## A4LD UPDATE HANDBOOK INDEX

AUTOMATIC TRANSMISSION SERVICE GROUP  
9200 S. DADELAND BLVD. SUITE 720  
MIAMI, FLORIDA 33156  
(305) 670-4161

Updated  
April, 2004

Figure 37

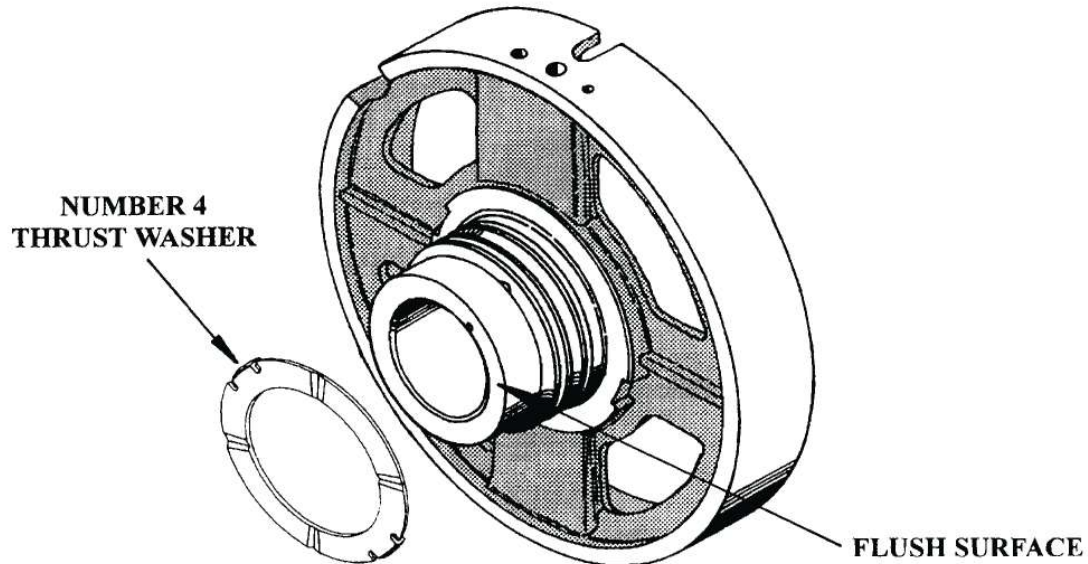
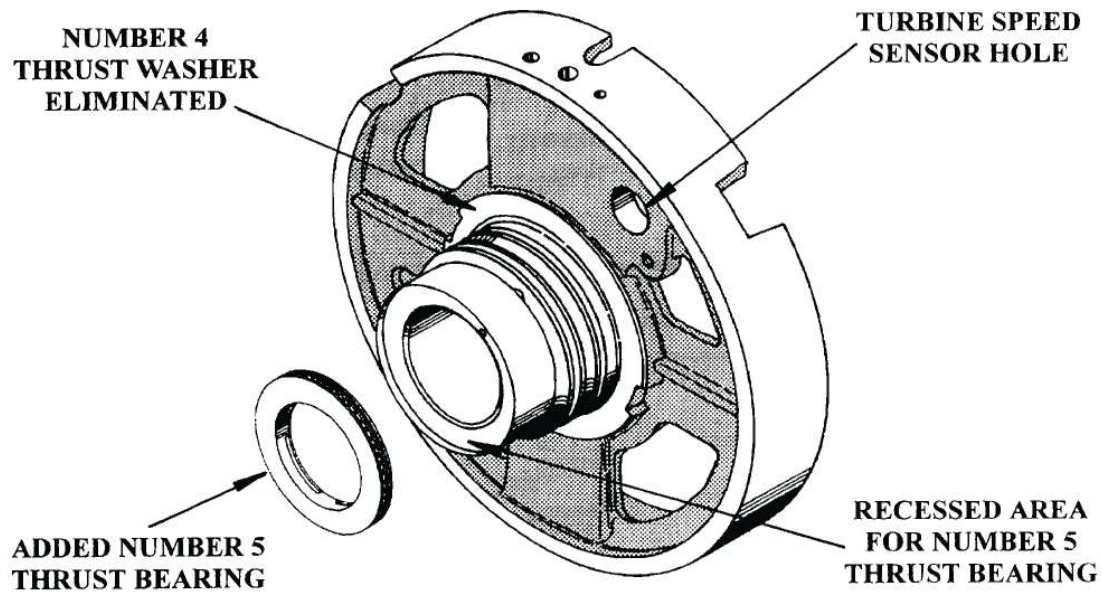
- (4) **CENTER SUPPORT** - When the "Snap Shell" was introduced in 1993, the number 3 thrust washer was eliminated (See Figure 35), & number 3 thrust bearing was added (See Figure 36). The addition of the number 3 thrust bearing required machining the surface deeper to accommodate the bearings added thickness (See Figure 36).  
The new design center support also has a machined recess at the base of the sealing ring hub to accommodate the newly added number 5 thrust bearing (See Figure 38). Remember, the number 4 thrust washer was eliminated when this change occurred (See Figure 37).  
There are four easy ways to identify the new design center support:

1. Machined recess for added number 3 thrust bearing (See Figure 36).
  2. Machined recess for added number 5 thrust bearing (See Figure 38).
  3. Machined hole for turbine speed sensor getting ready for 4R55E (See Figures 36 and 38).  
NOTE: Some new design center supports are cast for, but no hole has been machined.

Figure 39

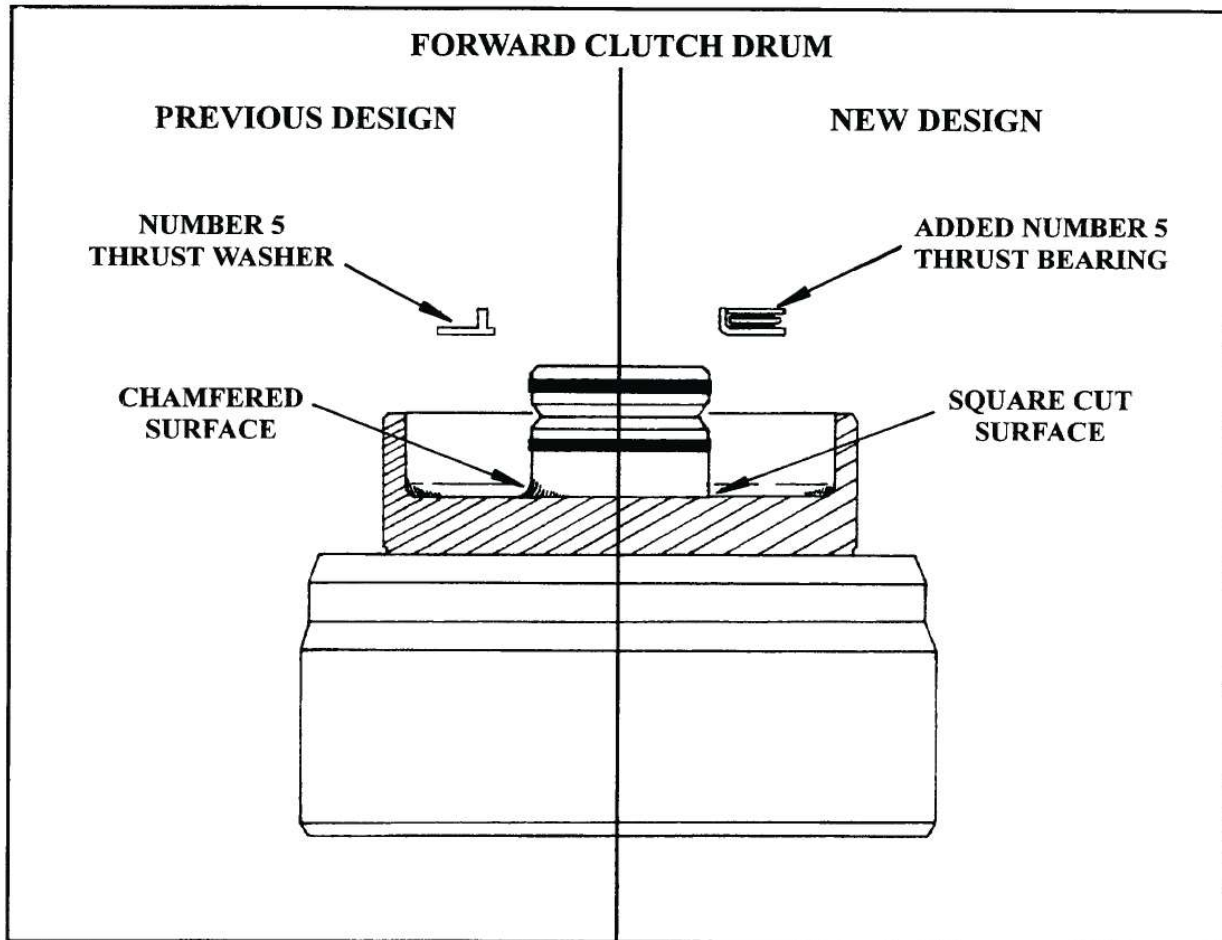
4. Casting number on new design center support is 92GT-7L328-AA.
- (5) **FORWARD CLUTCH DRUM** - Was machined at the base of the sealing ring hub to eliminate the chamfer, and provide a flat surface to accommodate the added number 5 thrust bearing, as shown in Figure 39.

- (6) The previous design center support **CANNOT** be used forward into **ANY** model that is using the "Snap Shell" (See Figure 35).
- (7) The new design forward clutch drum **WILL** retro-fit back on **ALL** previous models. (See Figure 39).

- (8) The previous design forward clutch drum **CANNOT** be used in 1993 and later models, as the chamfered area at the base of the hub will not let the number 5 bearing seat properly (See Figure 39).

Figure 40

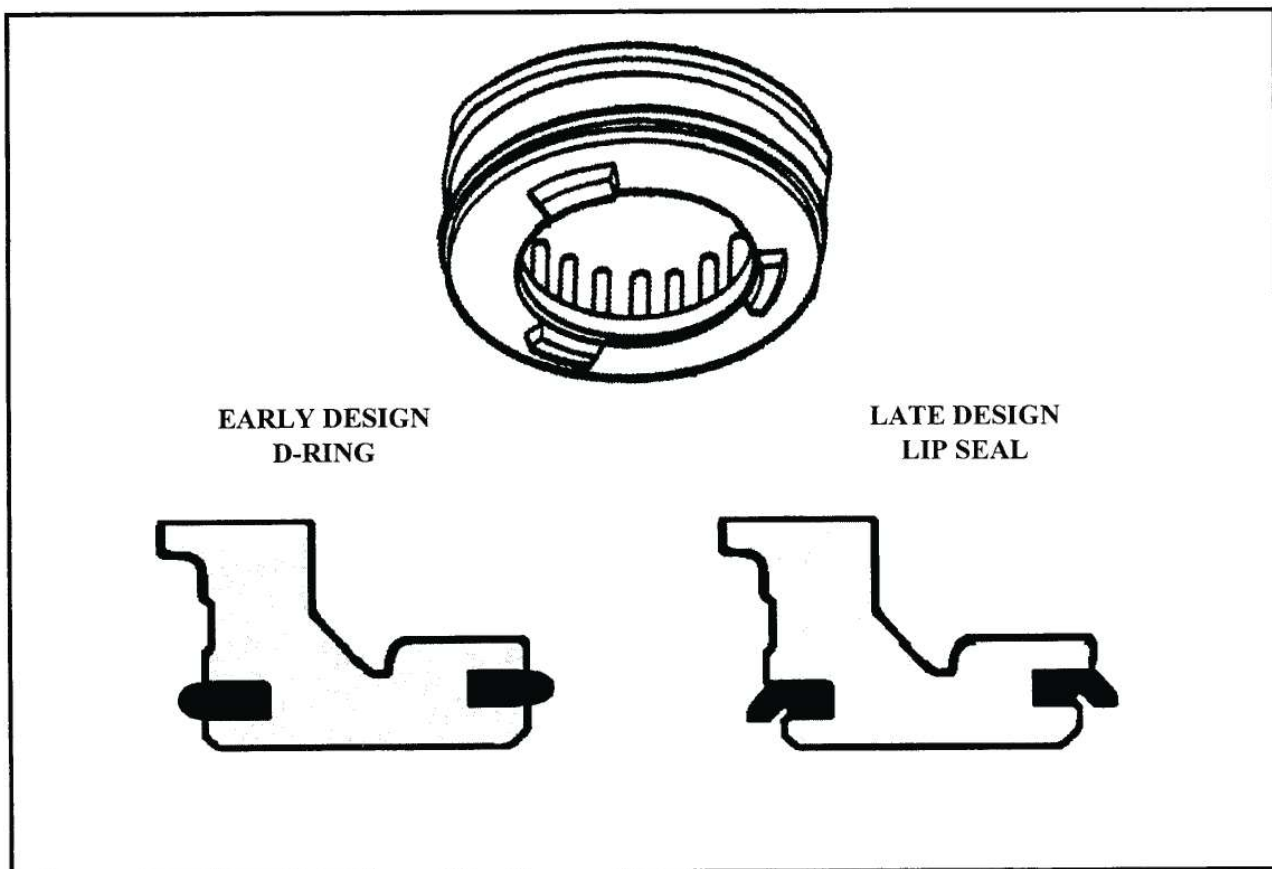
**CHANGE:** Both the overrun clutch and direct clutch piston seals were changed in 1987 from "D"-ring seals to lip seals (See Figure 40).

Although the early design "D"-ring & piston will interchange, we recommend using the later design lip seal, which requires changing the piston.

Figure 41

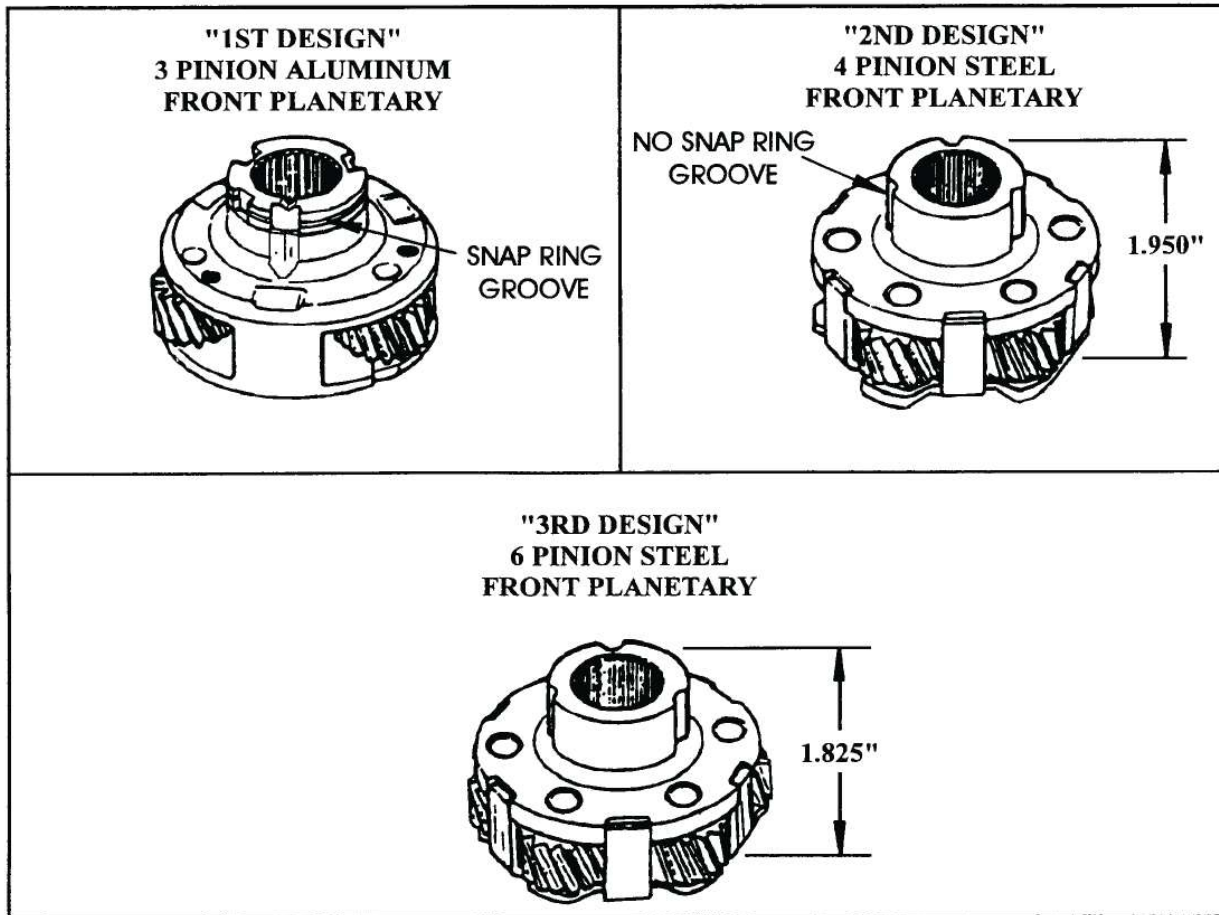
**CHANGE:** Sometime in model year 1987, the 1st design **3 pinion aluminum** front planetary carrier was replaced with a revised **4 pinion steel** front planetary carrier (See Figures 41 and 43). In model year 1990, on 4.0L engine models only, the steel front planetary carrier was once again revised to a **6 pinion steel** carrier (See Figures 41 and 43). These changes have affected many of the related parts and created confusion for many rebuilders.

- (1) **FRONT PLANETARY CARRIER** - The 1st design **3 pinion aluminum** carrier was eliminated and replaced with a revised **4 pinion steel** carrier. The snap ring groove and the snap ring that previously retained the carrier into the ring gear were eliminated (See Figure 41). In 1990 the steel carrier was once again upgraded with a **6 pinion steel** carrier, for 4.0L engine models only. The 6 pinion steel carrier was also shortened in overall height, by approximately .125", to accommodate a new design number 6 (3 piece) thrust bearing (See Figures 41 & 43). **NOTE:** The 1st Design 3 pinion aluminum and 2nd Design 4 pinion steel front carriers are no longer serviced by Ford Motor Co. They are now upgraded to the latest 3rd Design 6 pinion steel front planetary system, which comes as a service package and includes all necessary hubs and washers to make it compatible.

- (1) The **1st Design 3 pinion aluminum** front planetary carrier system, as shown in Figure 43, is recommended for nothing larger than 2.3L engine models. The 1st Design 3 pinion aluminum front planetary carrier is no longer serviced by Ford Motor Co. It now upgrades to the latest 3rd Design 6 pinion steel front planetary carrier system, which comes as a service package and includes all necessary hubs and washers to make it compatible, and is available under OEM part number F0TZ-7A398-E.

Figure 44

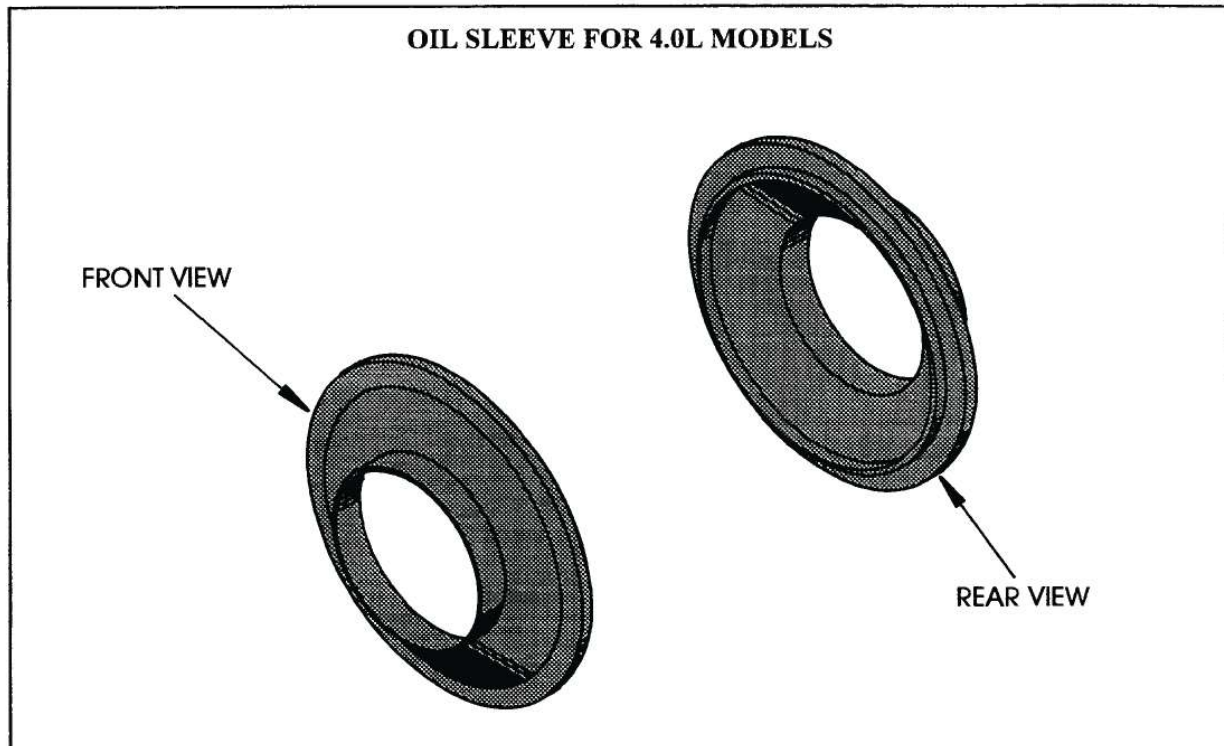
- (7) OIL SLEEVE - An added oil delivery sleeve, or lubrication guide, was added to the output shaft rear ring gear hub to direct lube oil from the added grooves in the hub, through the sun gear to the front planetary gear set (See Figures 44 and 47).

Figure 47  
AUTOMATIC TRANSMISSION SERVICE GROUP

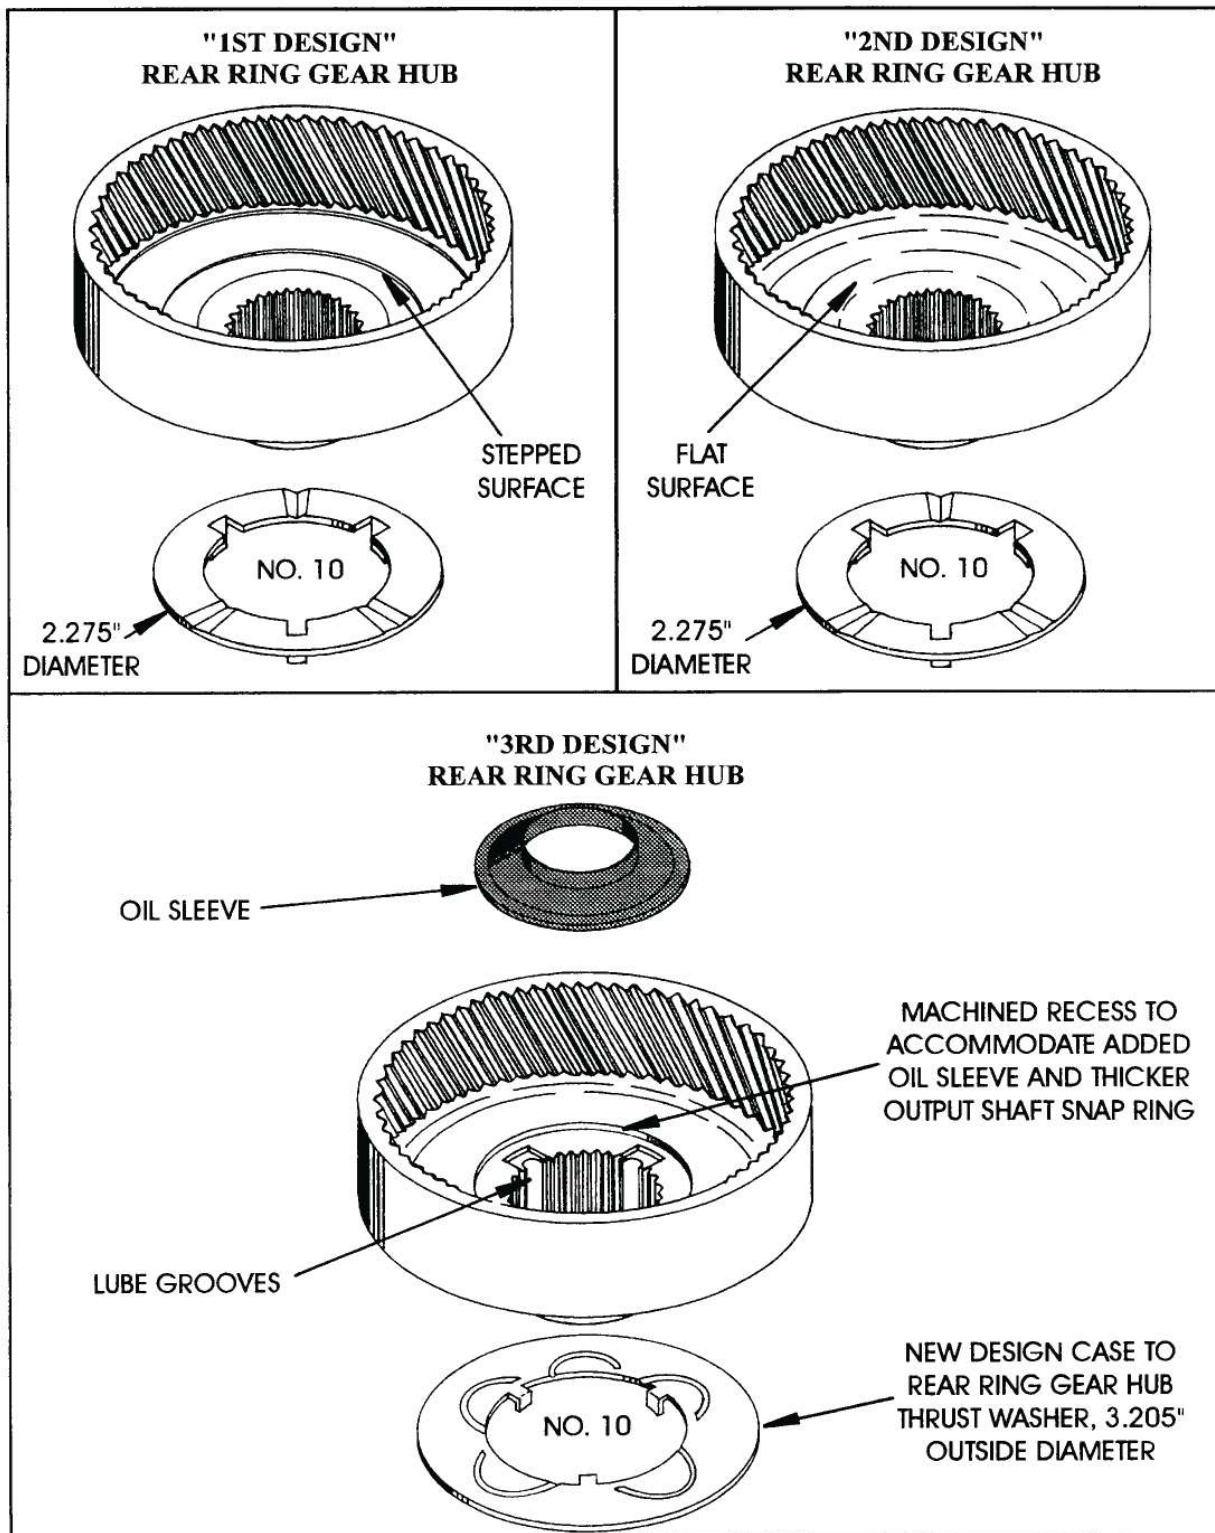
- (3) **REAR RING GEAR HUB** - The 1st design Rear Ring Gear Hub is identified with a "Stepped" washer surface as shown in Figure 47, and uses the 1st design number 9 thrust washer as shown in Figure 45. The 2nd design Rear Ring Gear Hub is identified with a "Flat" washer surface as shown in Figure 47, to accommodate the new 2nd design number 9 thrust washer (See Figure 45). The 3rd design Rear Ring Gear Hub is identified with a machined recess to accommodate the added oil sleeve and the thicker output shaft snap ring, and you can also see the added lube grooves in the spline area to accommodate the internal lube flow changes (See Figure 47). The 2nd & 3rd design Ring Gear Hub also has step removed out next to the ring gear teeth, to accommodate larger diameter of the 2nd design number 9 thrust washer (See Figure 47).

- (6) NUMBER 10 THRUST WASHER - Received a change in outside diameter (See Figure 47), and is now used to retain the low sprag end bearing on 4.0L engine models. Refer to the cutaway illustrations in Figure 49.  
The outside diameter on the number 10 thrust washer for the 4 pinion carrier is 2.275", and the outside diameter on the number 10 thrust washer for the 6 pinion carrier is 3.205", as shown in Figure 47.

Figure 48

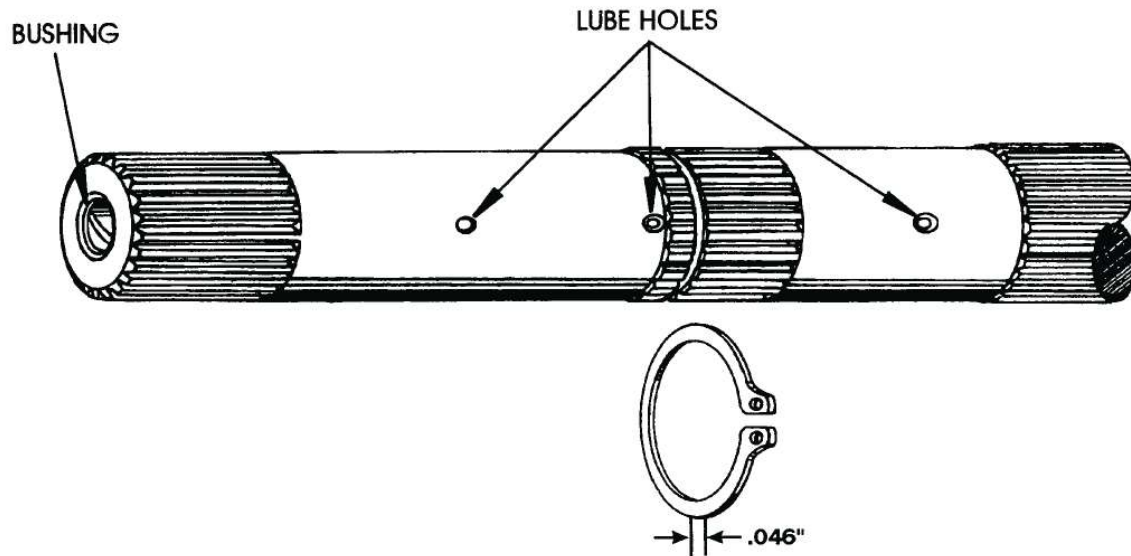
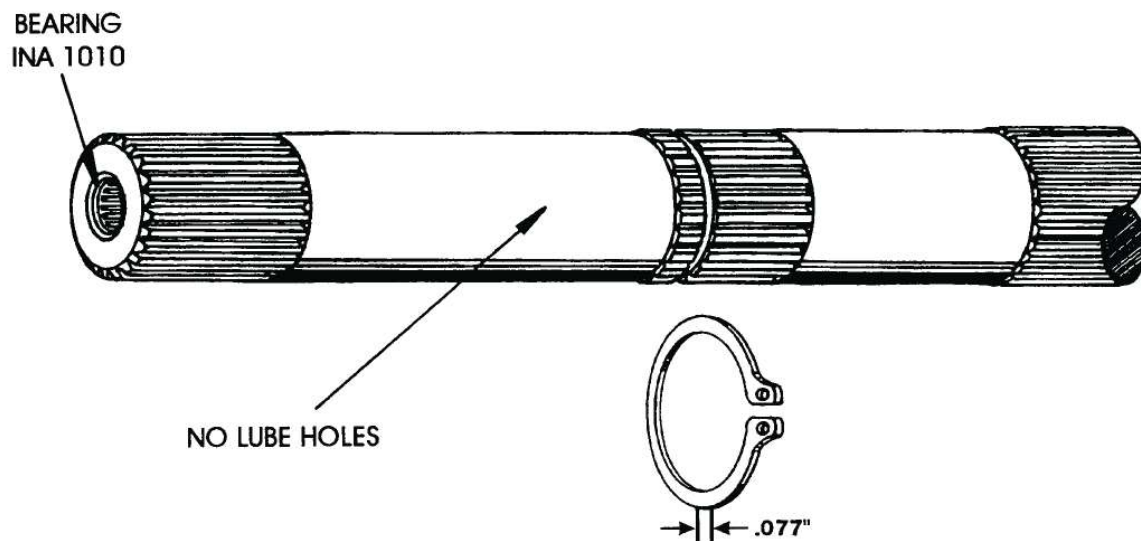
- (8) OUTPUT SHAFT - The Output Shaft was revised in three areas:
  - The front output shaft bushing was replaced with a caged needle bearing (See Figure 48).

- The output shaft snap ring groove was machined approximately .030" wider to make room for a revised thickness snap ring (See Figure 48). The new snap ring thickness is .077", as shown in Figure 48.

- The lube holes in the 1st design output shaft were eliminated entirely, to accommodate the revisions in the lube circuit on the 4.0L engine models (See Figure 48).

- (9) OUTPUT SHAFT SNAP RING - The snap ring that retains the rear ring gear and hub onto the output shaft on 4.0L models was increased in thickness, and now measures .077" thick. On all other applications the snap ring measures .046" thick (See Figure 48).

Figure 66

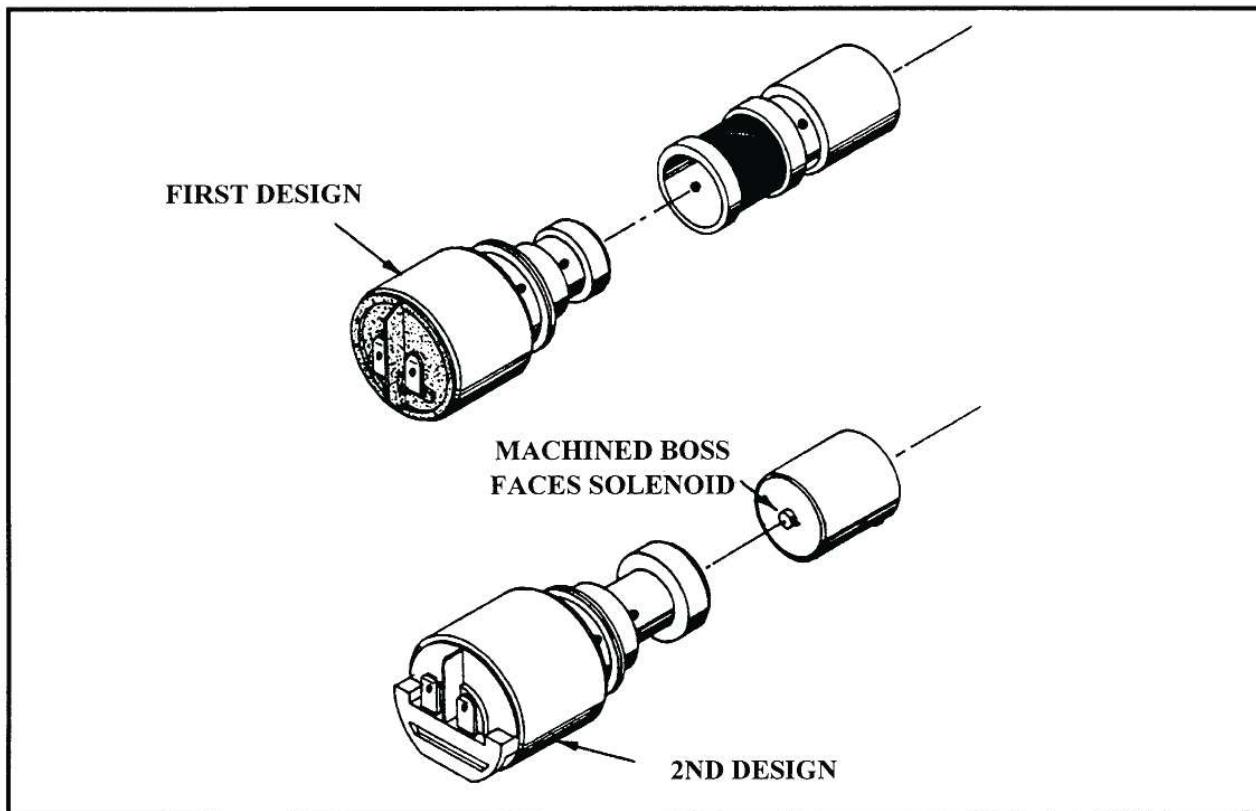
3-4 SHIFT SOLENOID - The 2nd design 3-4 shift solenoid eliminates the screen, has dimensional changes on the solenoid itself, and includes a new plug with a boss machined on one end. The plug must be installed with the machined boss facing the solenoid as shown in Figure 66.

2nd Design Solenoid.....E8TZ-7M107-A
